## NABCO ENTRANCES TECHNICAL BULLETIN

Date: Sept 26, 2013

## Rocker Switch Assemblies Re-located to Jambs on GT1175 Sliding Doors

Bulletin Number: **60**

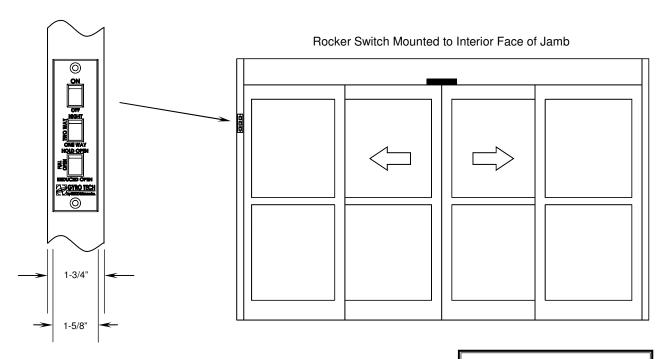
Effective October 1st we will be changing the location of the rocker switch assembly prep on GT1175 Series Sliding Doors Systems. The rocker switch will now be located on the 1-3/4" face of the jamb tube that is closest to the operator. As usual the switches will be mounted on the interior non-breakout side of the door. The switch cutout will be located at 71" from the bottom of the jamb or stile to the top hole on the switch plate.

The option will still exist to have the prep for the switch on the sidelite in lieu of the jamb face. The switch mounting height of 71" will apply to sidelites also. If you wish to have the switch prep on the sidelite, or any other special location, please indicate this clearly on your order. If no special switch location is requested then the jamb will be prepped as shown below. On surface applied units the switch will still be located on the vertical mullion as before.

This change will apply to all GT1175 models including the GT1175 Telescopic and GT1175 All Glass Systems.
